**ROCKFORD BOARD OF EDUCATION  
INVITATION FOR BID ON SUPPLIES, MATERIALS, EQUIPMENT OR SERVICES  
FOR SCHOOL DISTRICT NO. 205  
ROCKFORD, ILLINOIS**

IFB No.        **17-40 Rockford Public School District 205 School B, Zone 1**

RE:        **ADDENDUM NO. 7**

Rockford Public School District 205  
School B, Zone 1  
Rockford, IL  
Cannon Project No. 005005.00

**C07**

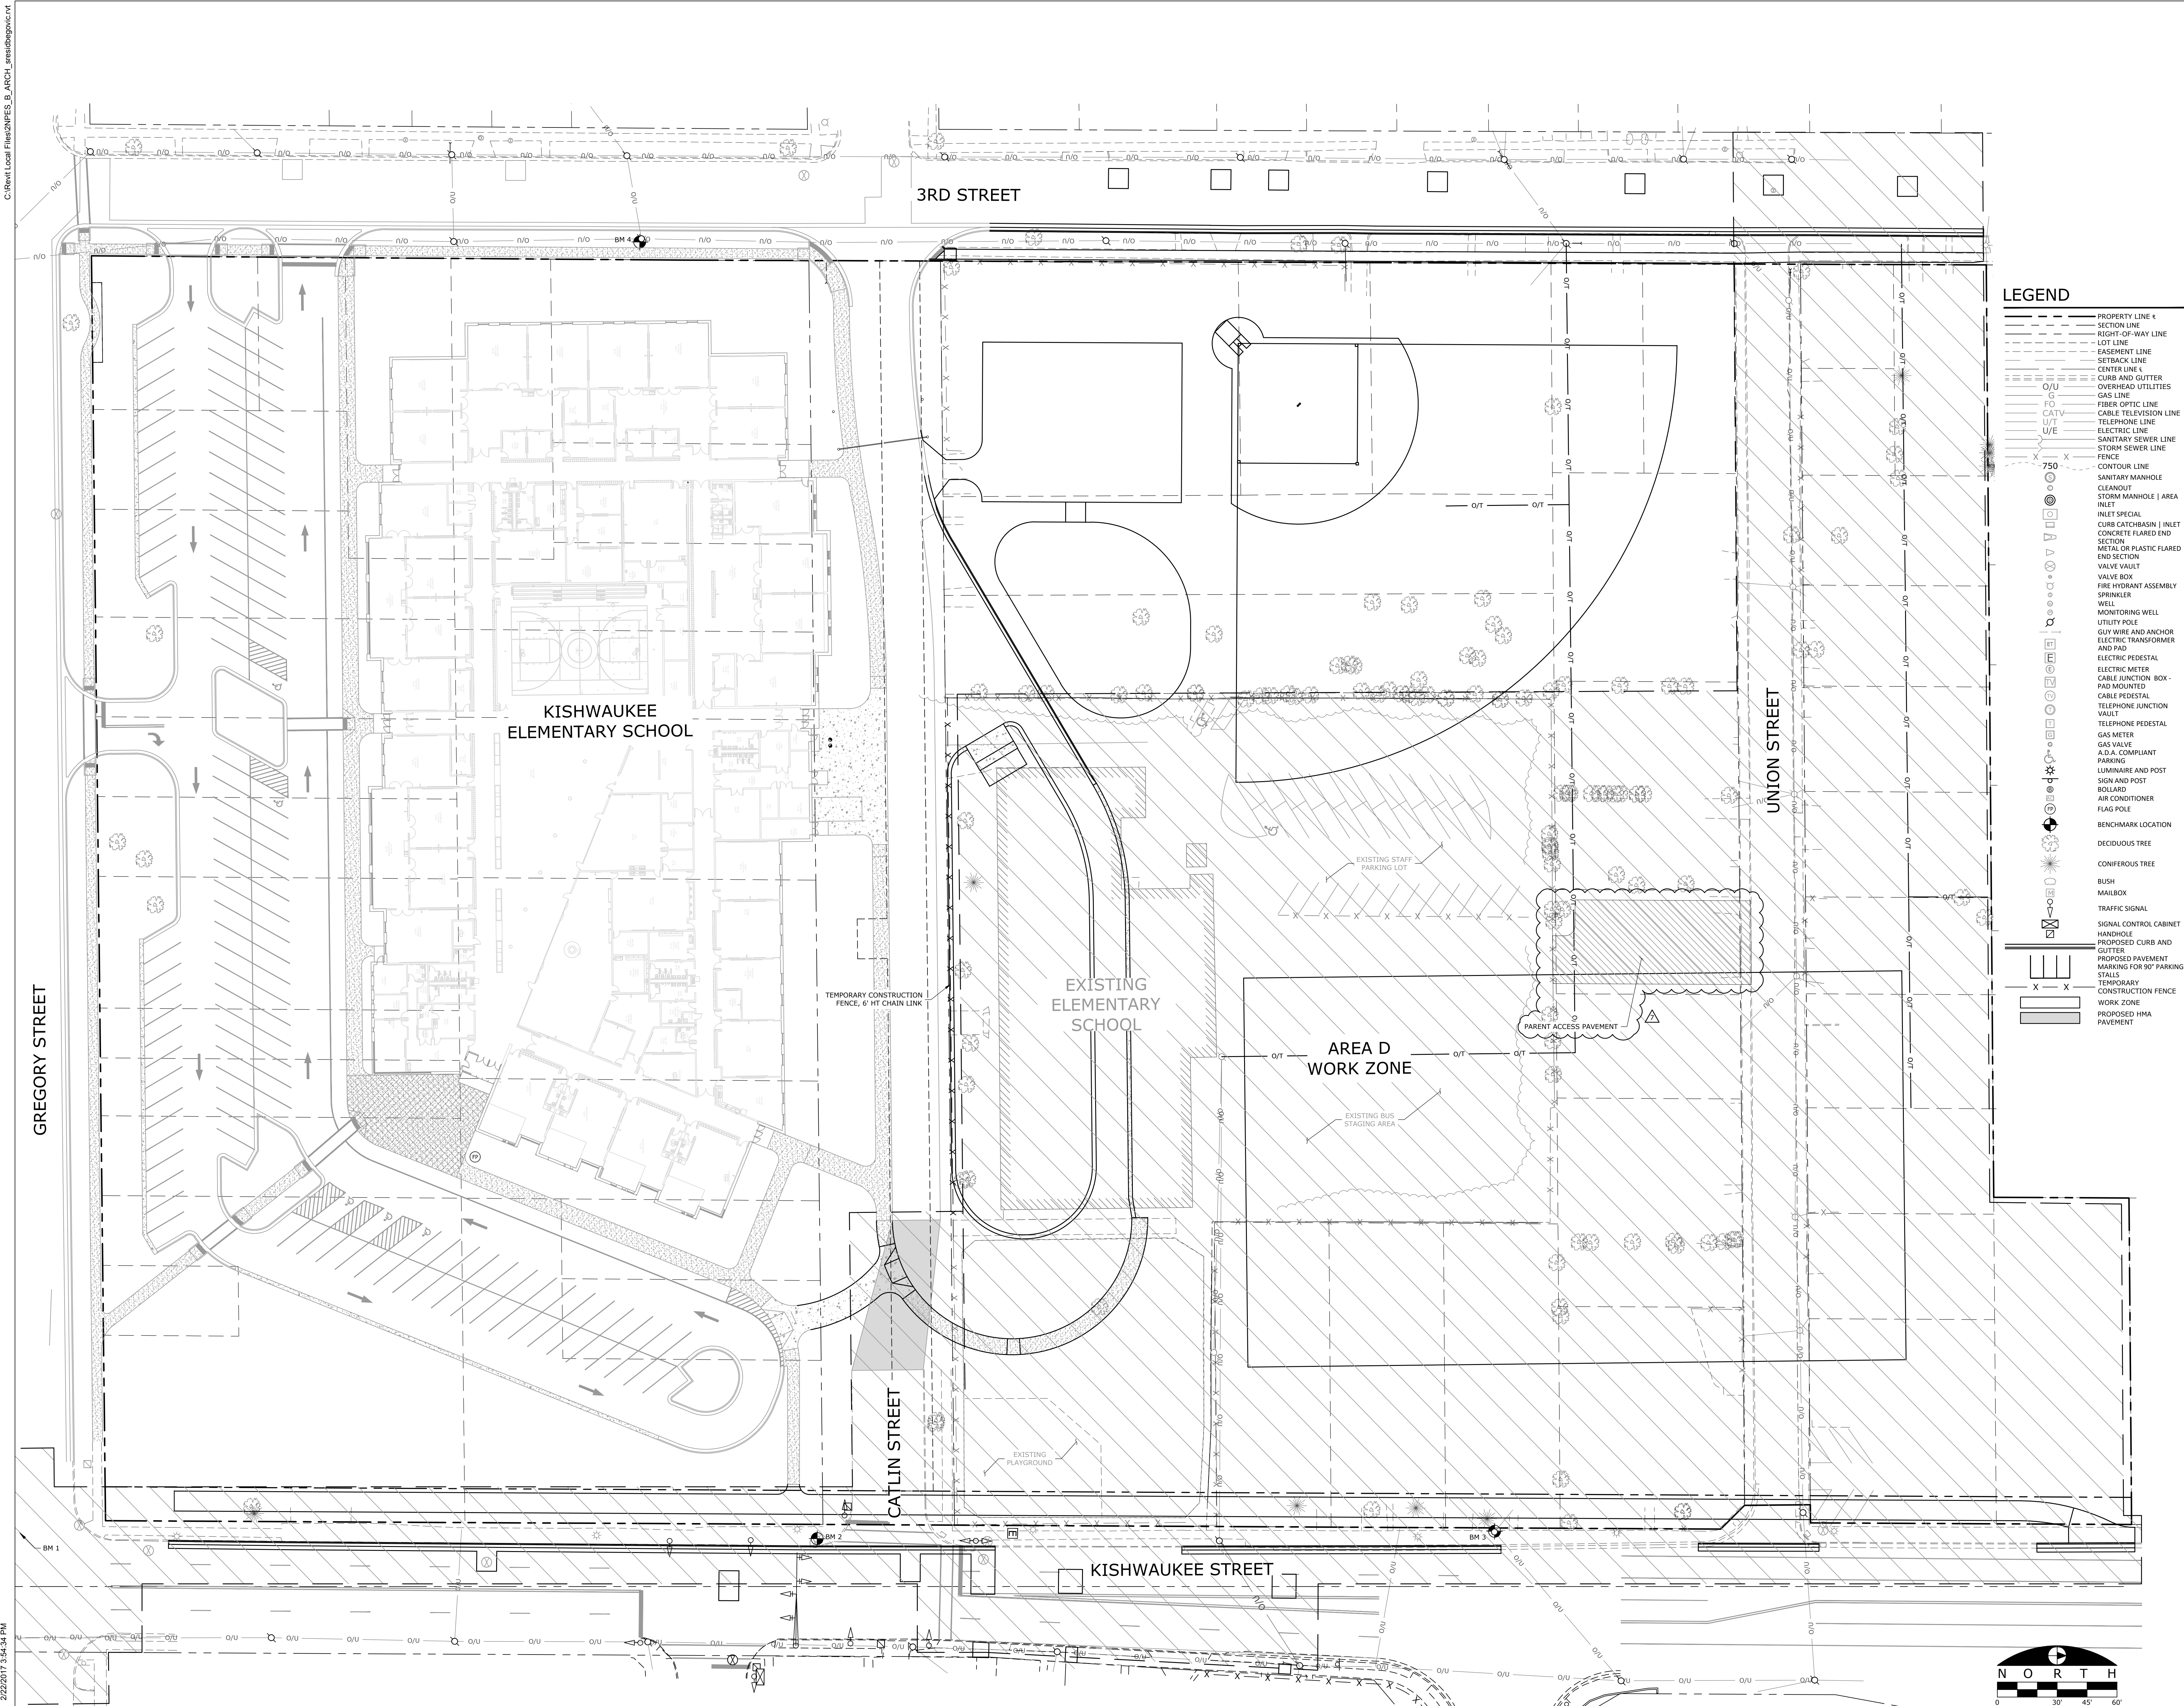
4. C07 - AREA C WORK SCOPE

- A. Revised notes to eliminate reference to dates.

**C08**

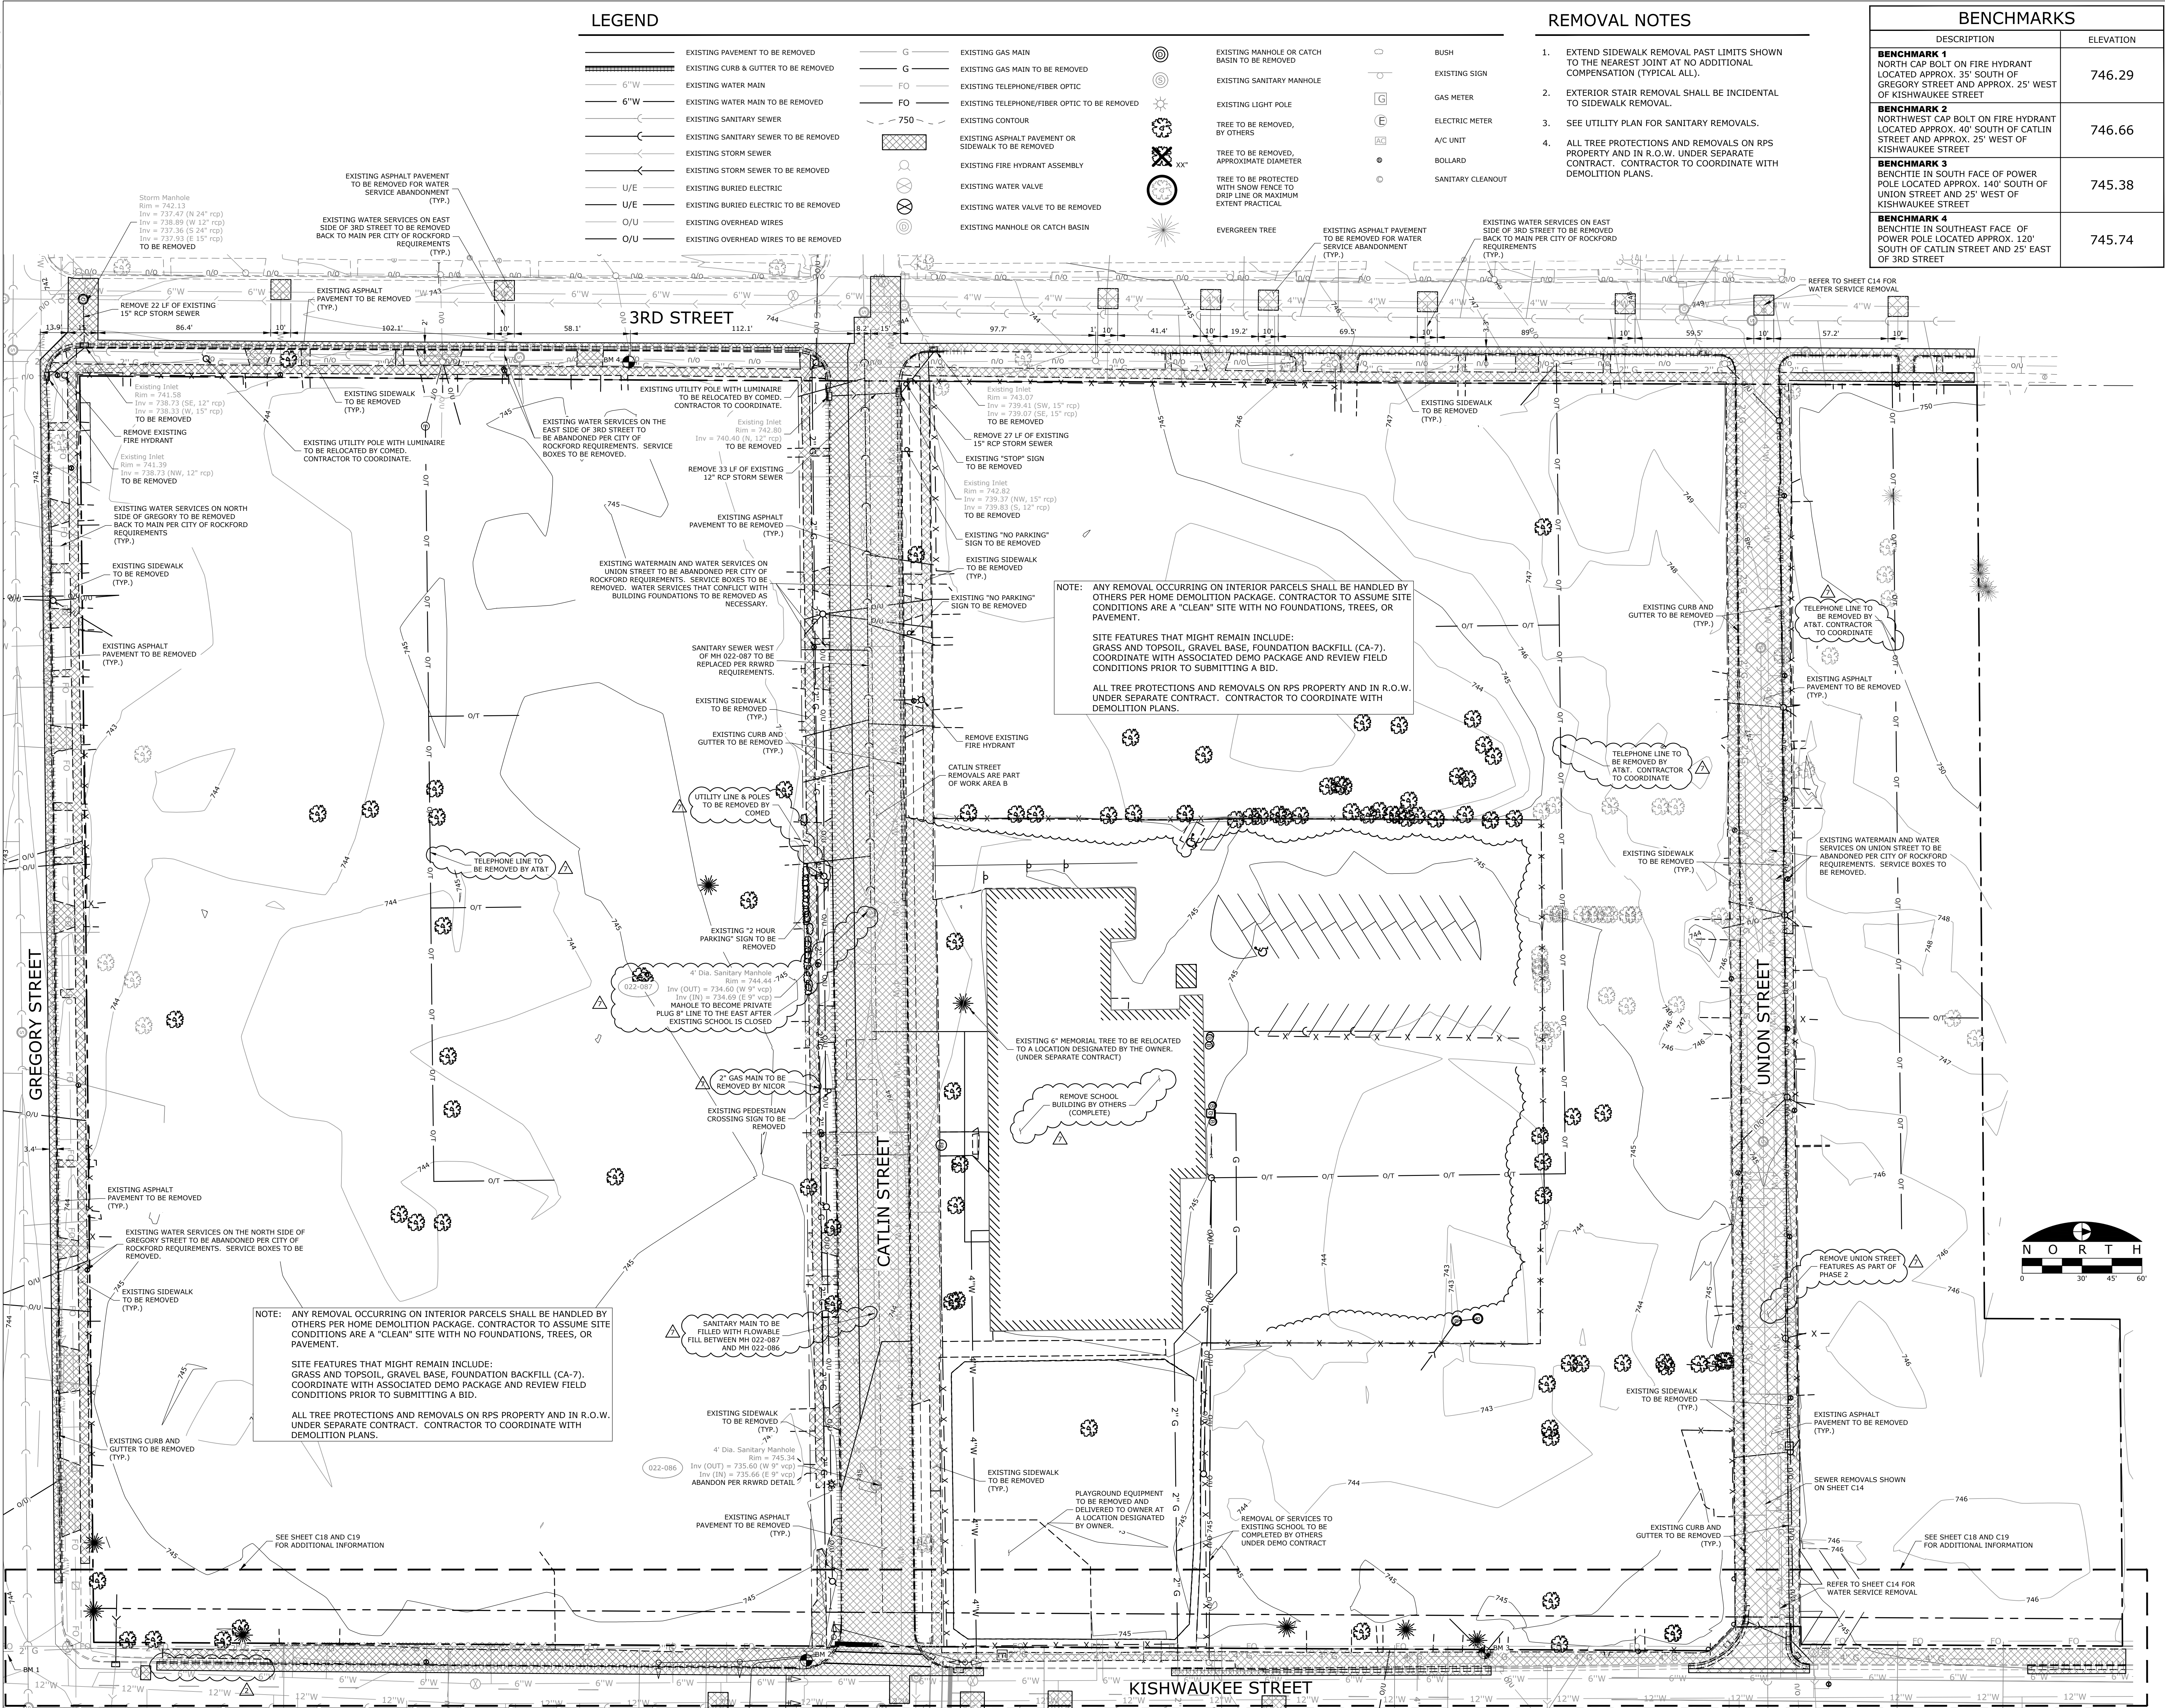
5. C08 - AREA D WORK SCOPE

- A. Revised notes to eliminate reference to dates.

C09

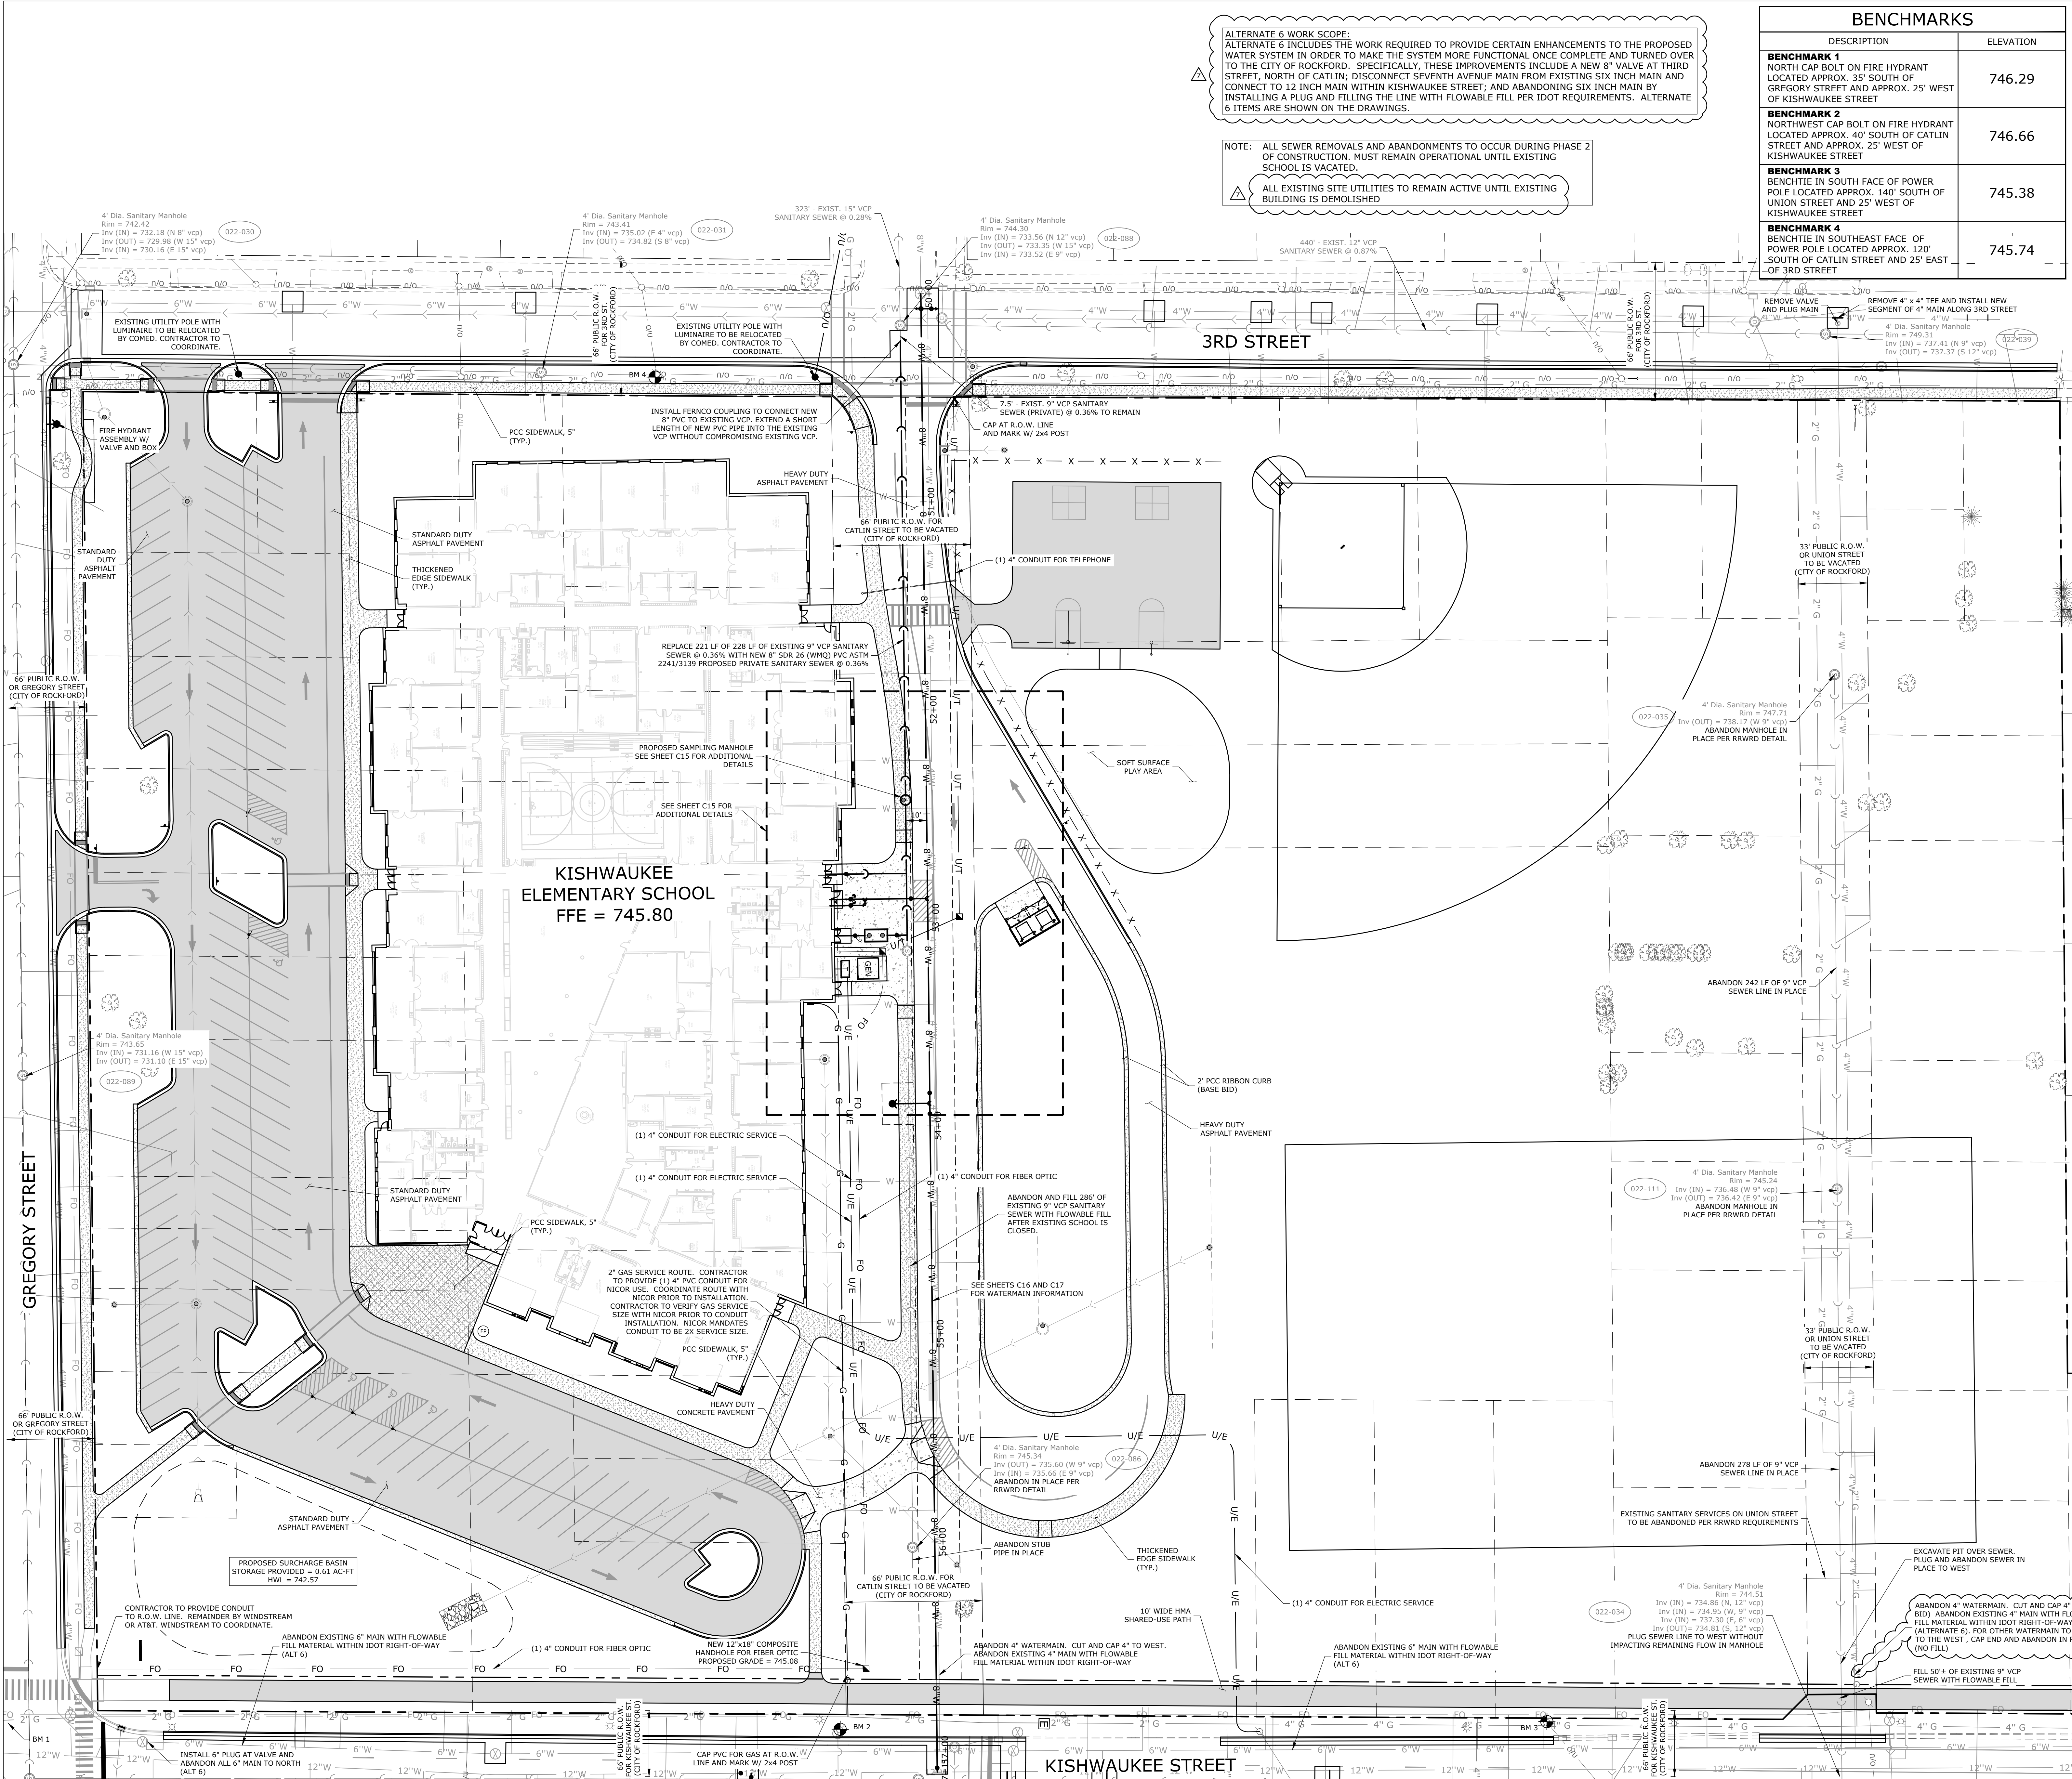
6. C09 – EXISTING CONDITIONS AND REMOVALS PLAN

- A. Revised notes to eliminate reference to dates.
